**INQUIRY INTO COAL SEAM GAS
OPERATIONS IN NEW SOUTH WALES**

SUBMISSIONS BY DR PHILIP PELLIS

RE: REVIEW OF COAL SEAM GAS ACTIVITIES IN NSW

Figure 1: Rain gauges.

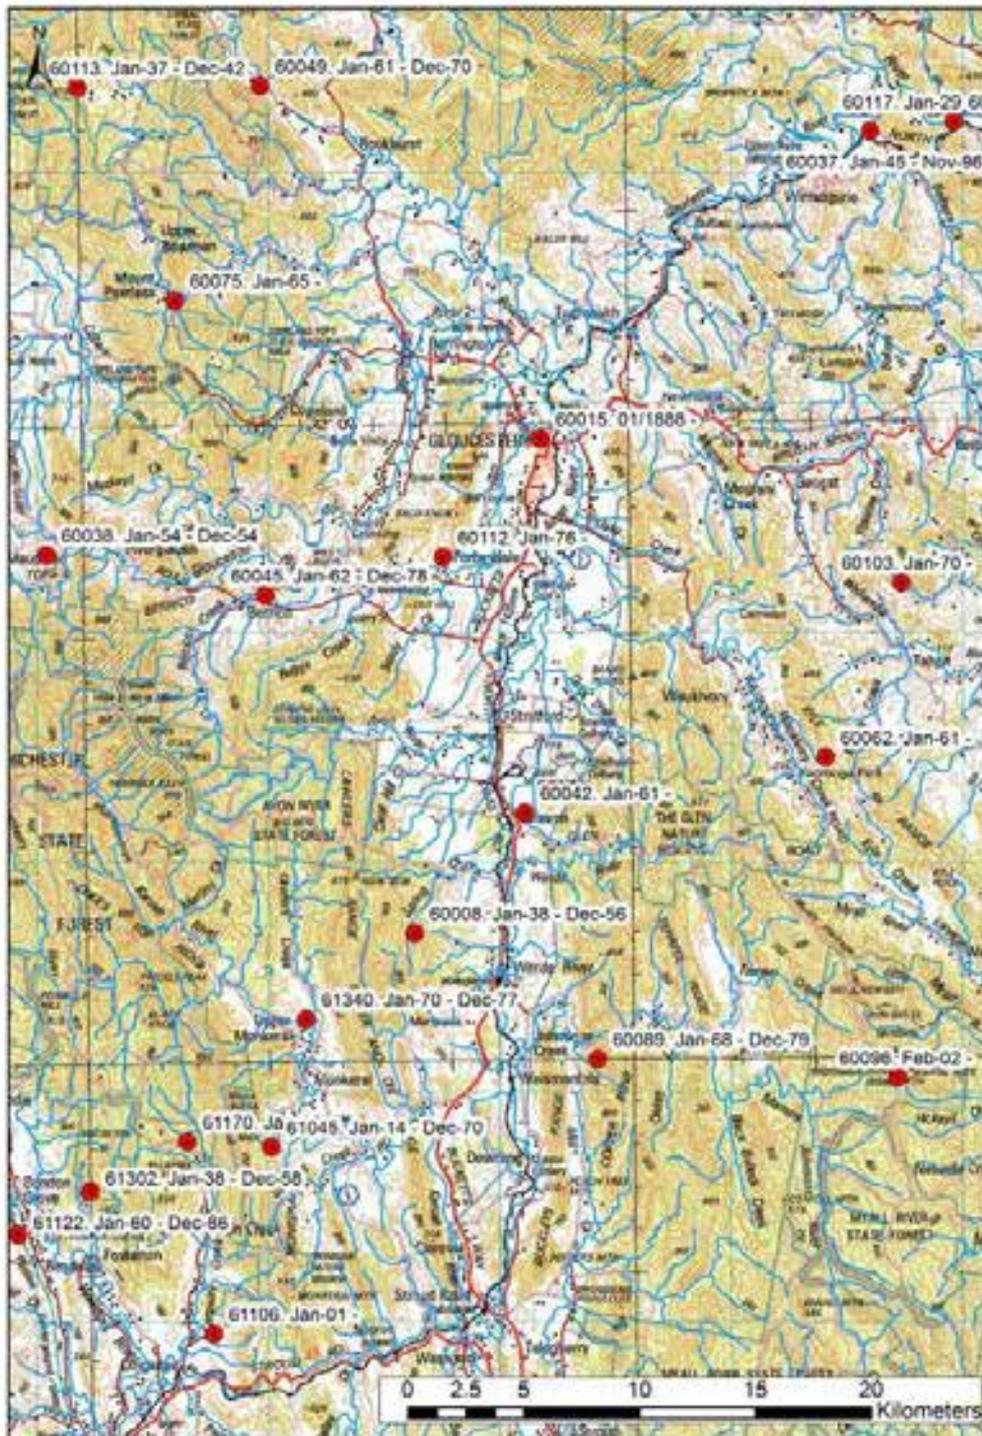
Figure 1 shows the rainfall stations in the project area. Recording at Gloucester commenced in 1888. In addition, the Queensland Department of Environment and Resource Management (**QDERM**) provides a service whereby they generate 120 year rainfall records, for any locality, by interpolation of surrounding records. This allows filling of gaps in existing long term records, such as those from Gloucester.

Figure 2: Cumulative rainfall from 1889.

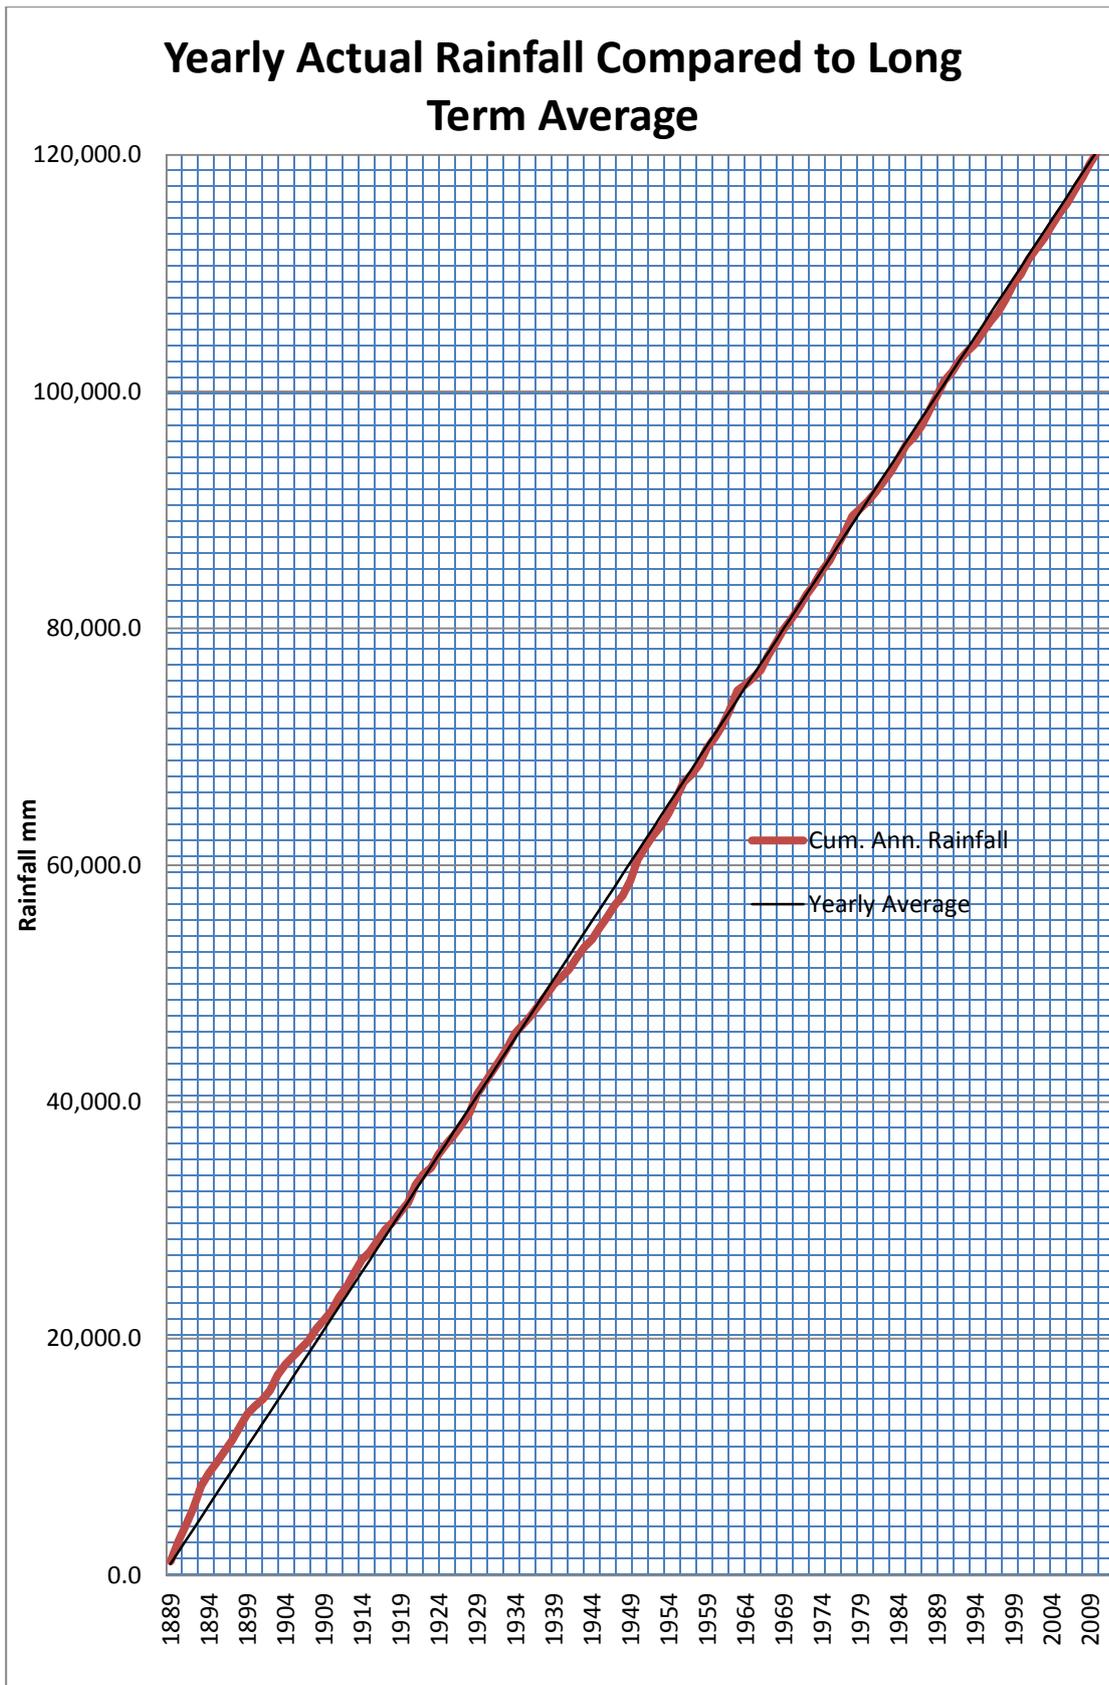
Figure 2 shows the cumulative rainfall, compared with the straight line if every year had average rainfall. This is to explain the meaning of a rainfall plot in the PB report.

The differences between the straight line and the actual cumulative rainfall in Figure 2, above, is what PB call “cumulative deviation rainfall”, and plot in their Figure 3.2 (reproduced below). Our corresponding graph using the data from 1889 is given in our Figure 3.

Figure 3: Rainfall data from 1889 to 2011.

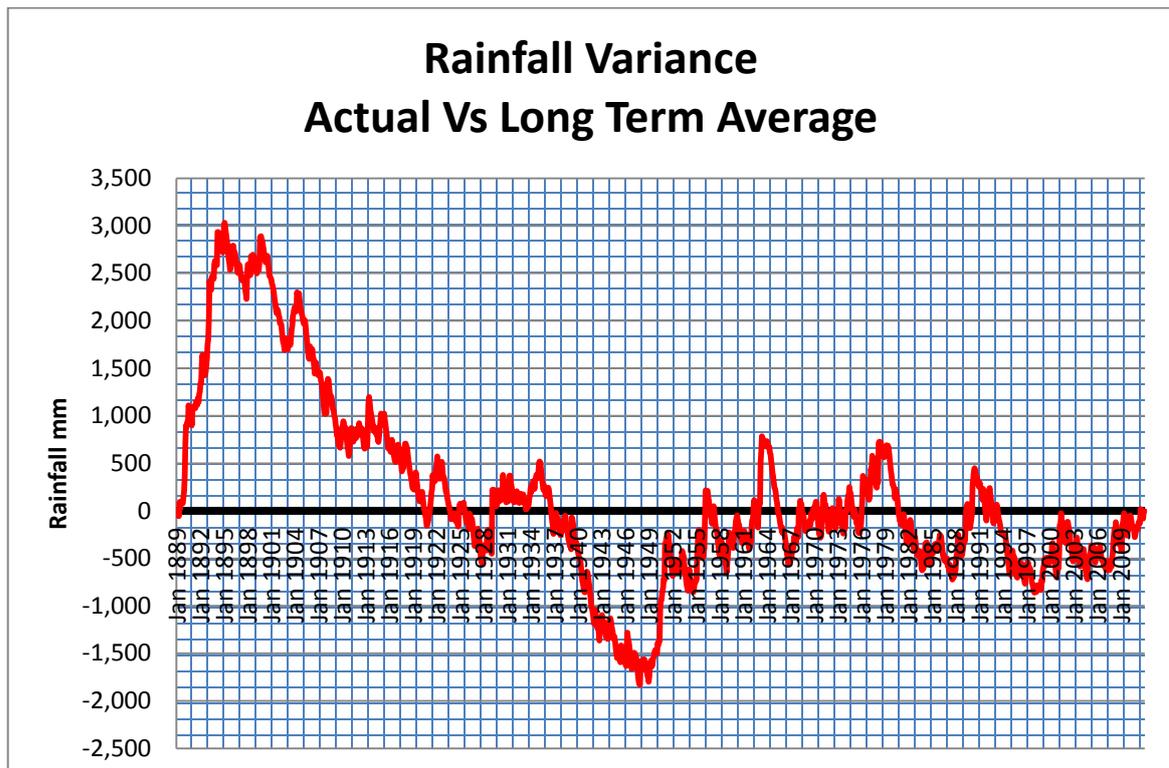
It is clear that the rainfall record used by PB does not cover the quite substantial variations that have occurred since 1889. Therefore, it is reasonable to think that conclusions drawn by PB from the post-1976 records are not appropriate, even down to factual matters such as average annual rainfall.

Figure A : Available rainfall gauging stations and length of record

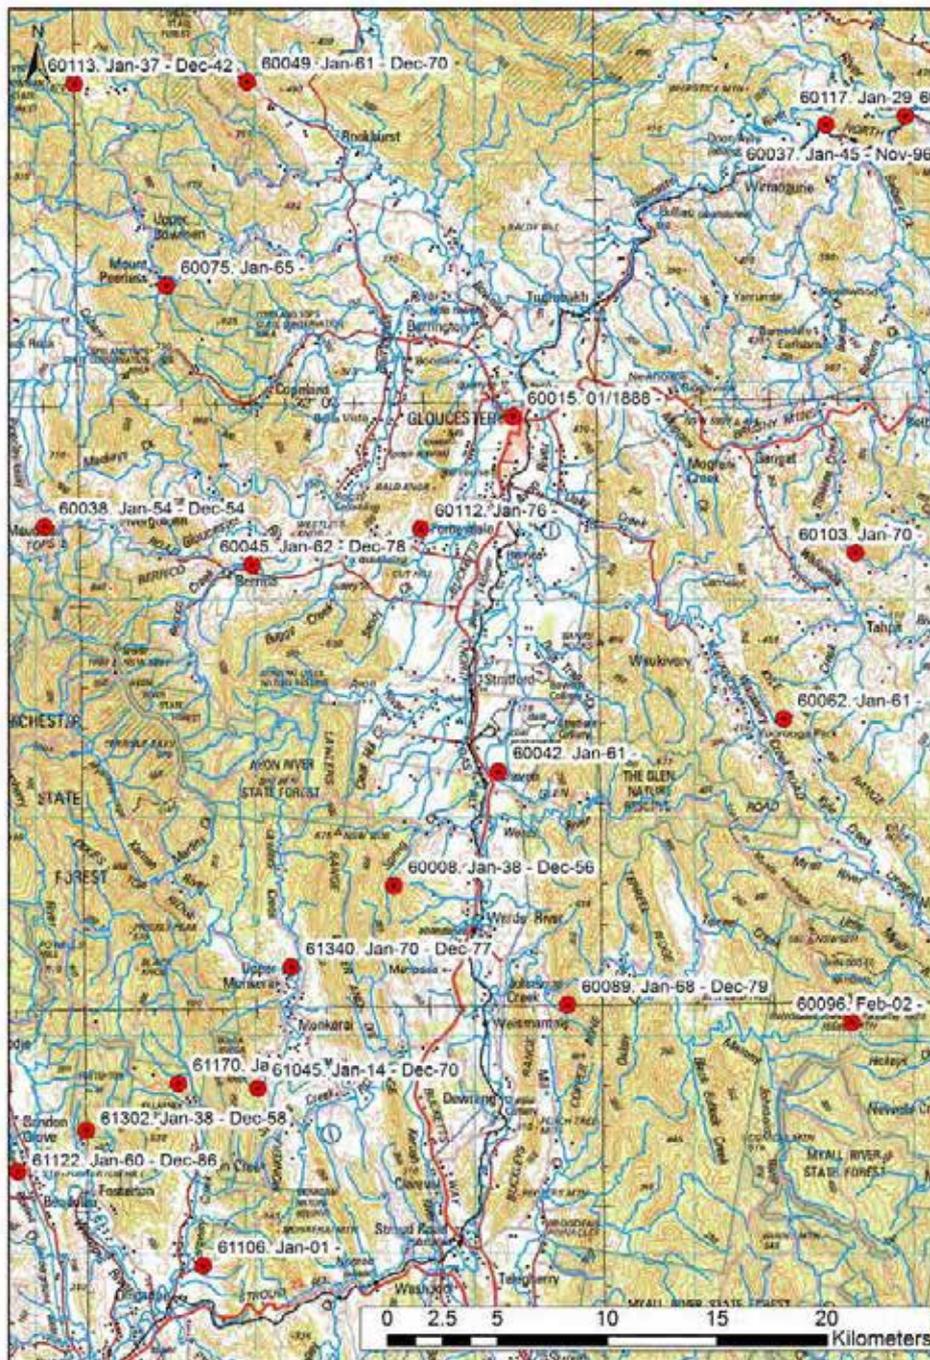
Continuous rainfall data from the Gloucester Hiawatha Station (60112) is available from 1976 and is used in the Phase 2 report. (This is despite the existence of far longer records from other stations, particularly the one at Gloucester – see Figure A).

Figure B Published geological plan of Gloucester basin (not given in the Phase 2 report)

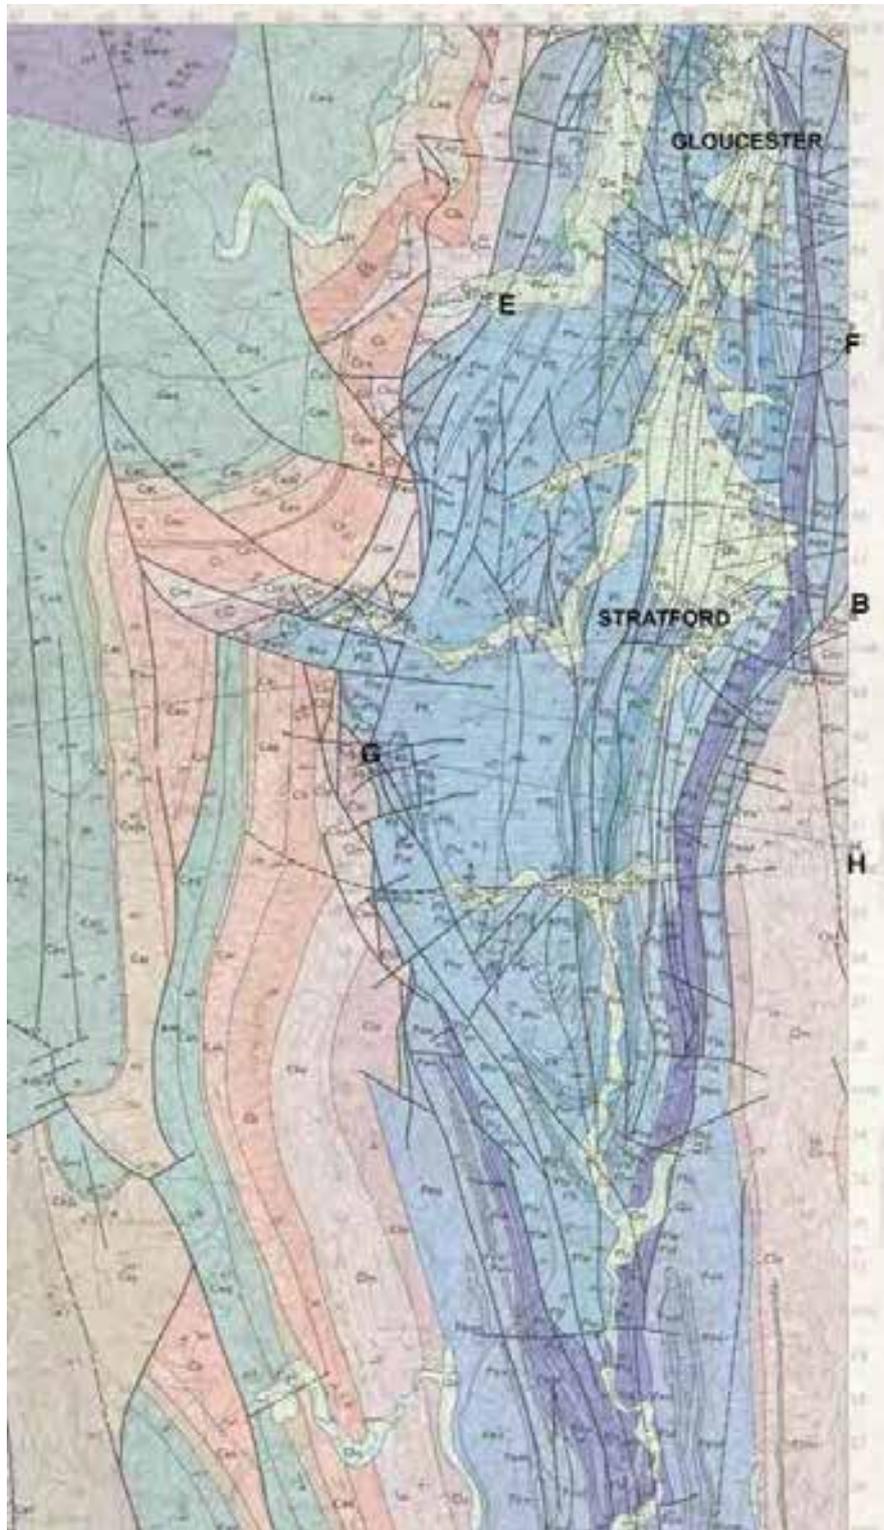
The Gloucester Basin represents a complex geological system formed by the interplay of extensional tectonic faulting and high rates of sediment supply (see Figure B).
